LU DLUM FIRST ADDITION TO SEDGWICK COUNTY, KANSAS

RE: S/D 00-01 -- One-Step Final Plat of LUDLUM FIRST ADDITION

RE: S/D 00-01 -- One-Step Final Plat of LUDLUM FIRST ADDITION

CASE NUMBER: S/D 00-01 -- LUDLUM 1ST ADDITION

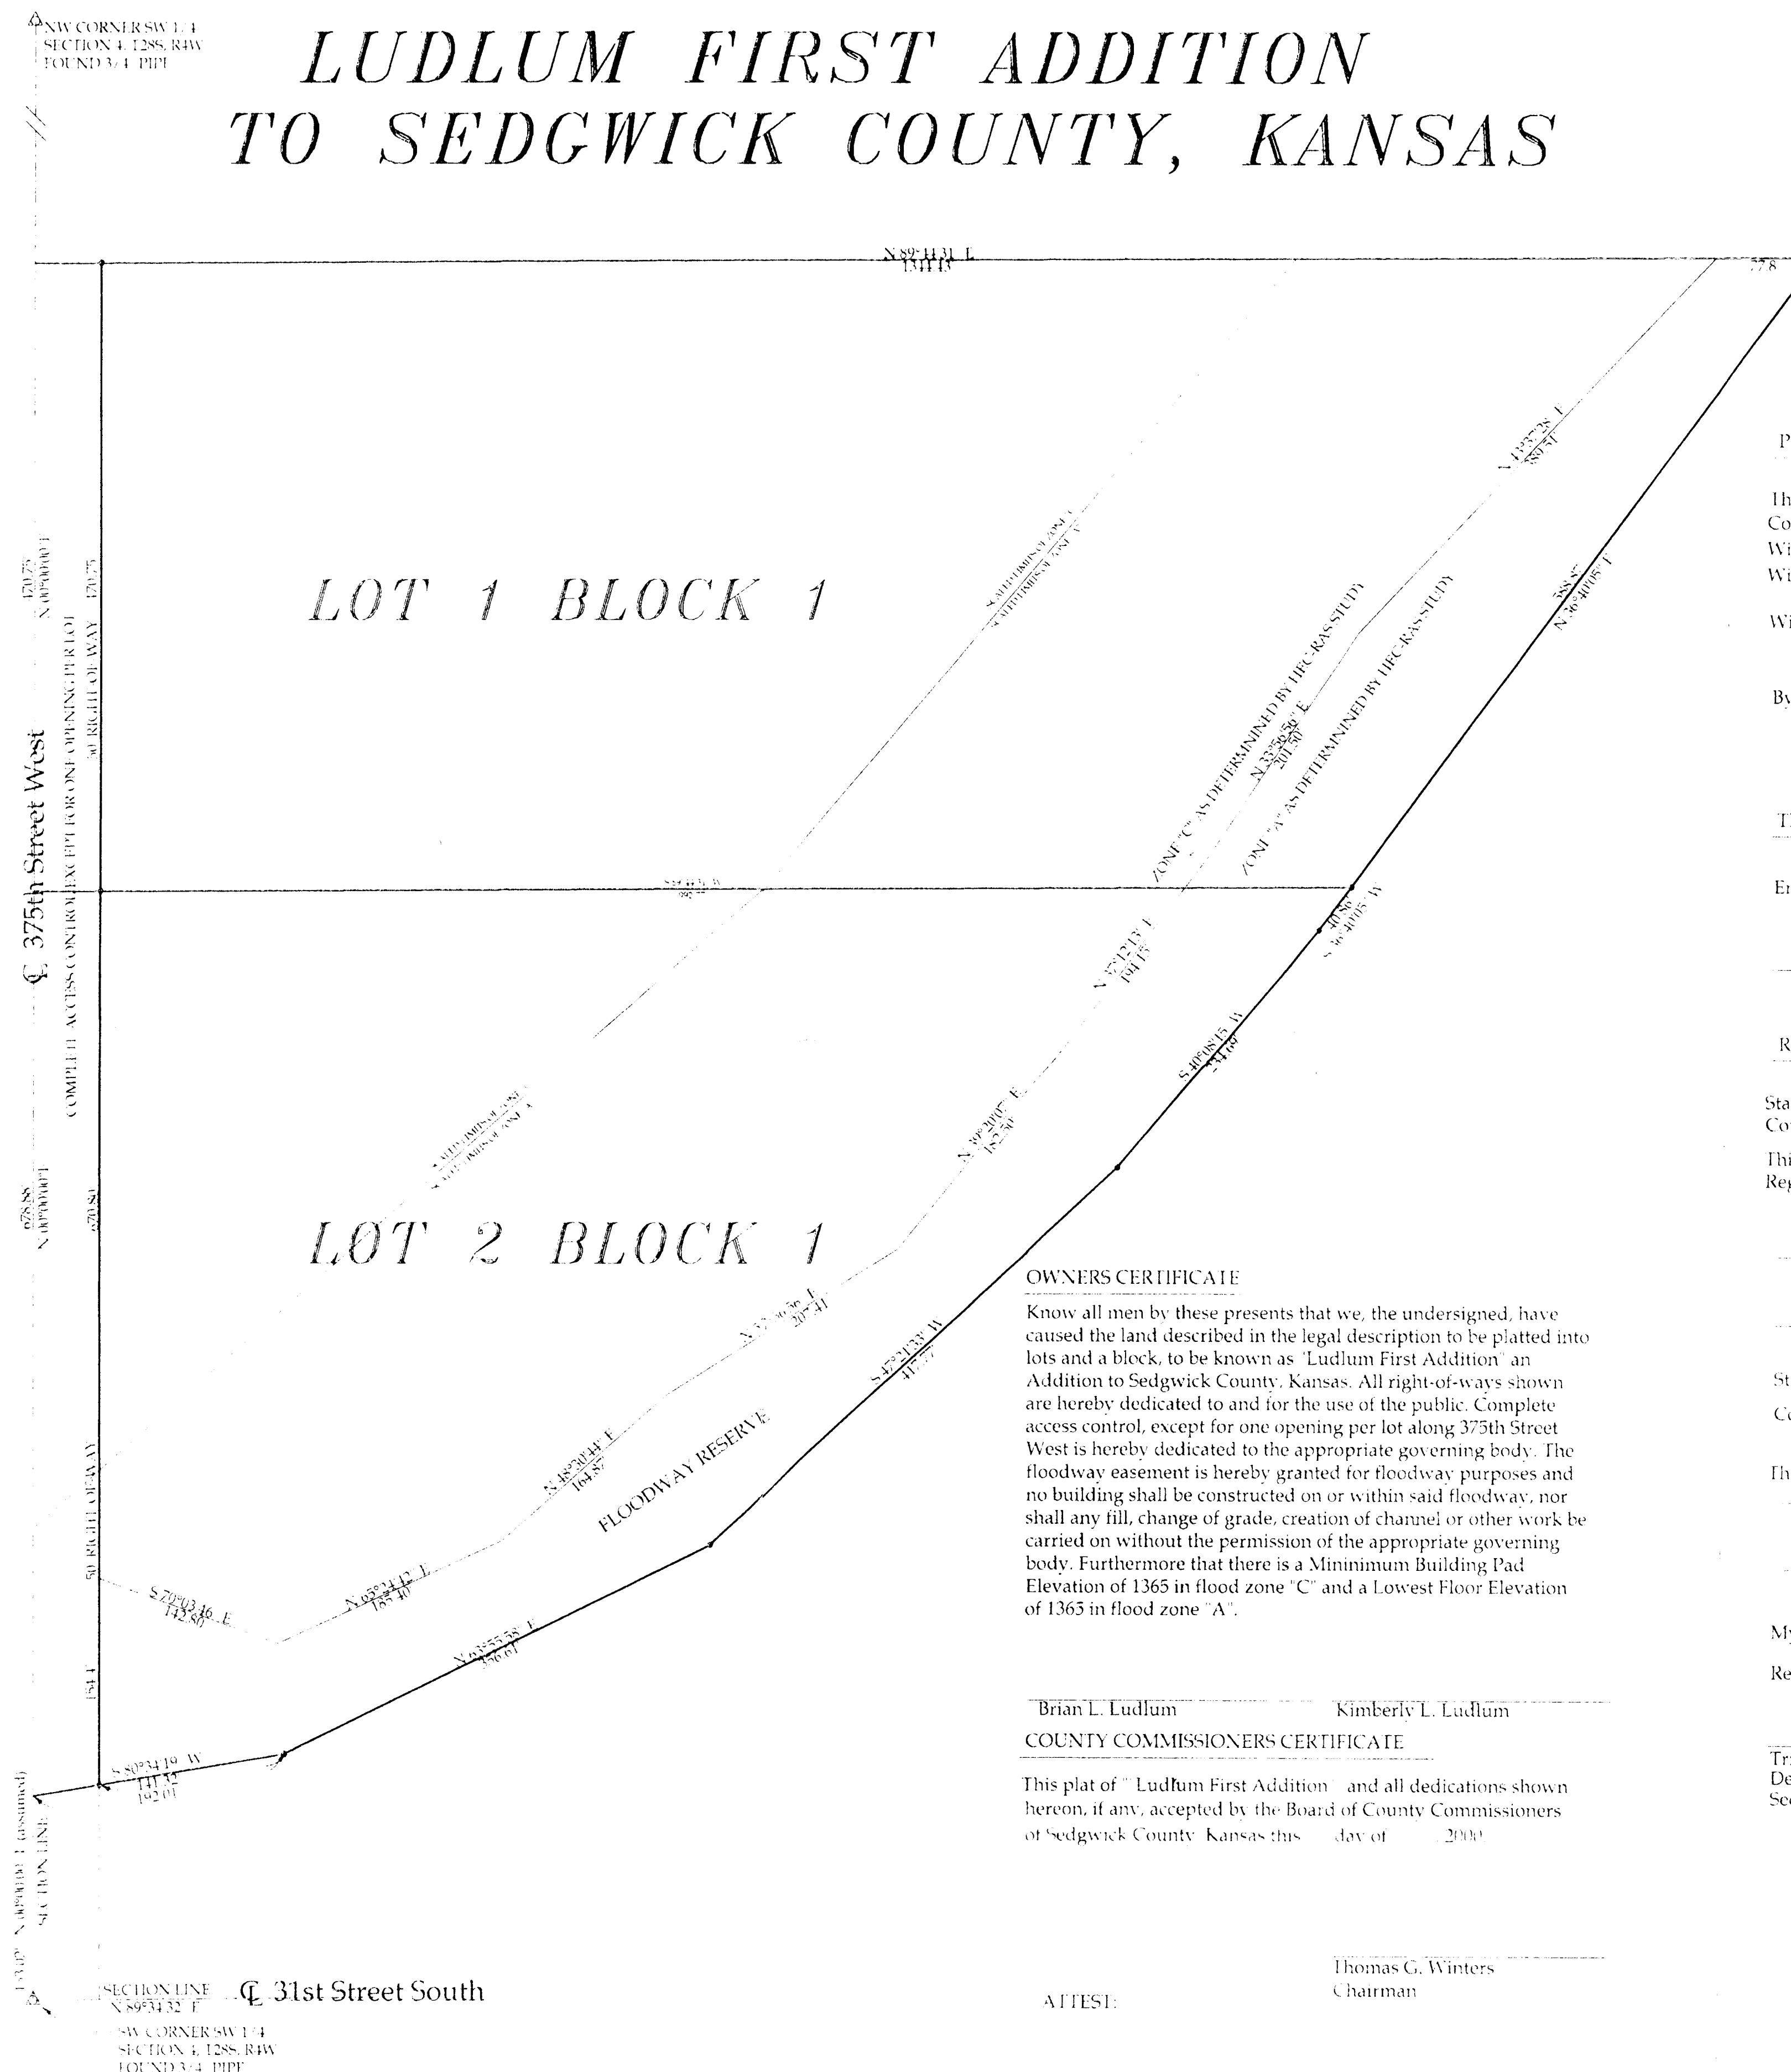
- D. **County Engineering** needs to comment on the status of the applicant's drainage plan. **The Floodway easement needs to be relabeled as a Floodway Reserve. The limits of the Floodway Reserve need to be labeled and dimensioned. The lowest floor or minimum building elevations need to be established as applicable. A HEC Quick-2 flood study run needs to be completed; which may require the revision of the floodway boundaries. A floodway reserve easement needs to be provided.**

- E. The plat proposes one access opening per lot along 375th St. West. The platlor's text shall reference "one opening per lot" and denote access controls as being dedicated to the appropriate governing body.

- F. Lot line dimensions need to be revised for the north and south lines of Lot 1 and along the southerly line of Lot 2.
- G. The owner's certificate shall reference the language "platted into lots" and include a signature line.

- H. The notary acknowledgment shall reference the owner's name.
- I. The Chairman of the County Commissioners needs to be revised to read "Thomas G. Winters".

- J. The sentence regarding easements in the County Commissioners' certificate needs to be eliminated.
- K. The language "at ____ a.m. - p.m." needs to be added to the signature block of the Register of Deeds.

- M. The MAPC signature block should be revised to reference "Francis S. Garofalo" as the MAPC Chairman.
- N. The legal description needs to be revised to accurately portray the land being platted. The distances on the drawing need to correspond with those denoted within the legal description.

- D. County Engineering needs to comment on the status of the applicant's drainage plan. The Floodway easement needs to be relabeled as a Floodway Reserve. The limits of the Floodway Reserve need to be labeled and dimensioned. The lowest floor or minimum building elevations need to be established as applicable. A HEC Quick-2 flood study run needs to be completed; which may require the revision of the floodway boundaries. A floodway reserve easement needs to be provided.

- E. The plat proposes one access opening per lot along 375th St. West. The plat's text shall reference "one opening per lot" and denote access controls as being dedicated to the appropriate governing body.

- F. Lot line dimensions need to be revised for the north and south lines of Lot 1 and along the southerly line of Lot 2.
- G. The owner's certificate shall reference the language "platted into lots" and include a signature line.

- H. The notary acknowledgment shall reference the owner's name.
- I. The Chairman of the County Commissioners needs to be revised to read "Thomas G. Winters".

- J. The sentence regarding easements in the County Commissioners' certificate needs to be eliminated.
- K. The language "at ____ a.m. – p.m." needs to be added to the signature block of the Register of Deeds.

- M. The MAPC signature block should be revised to reference "Francis S. Garofalo" as the MAPC Chairman.

- N. The legal description needs to be revised to accurately portray the land being platted. The distances on the drawing need to correspond with those denoted within the legal description.
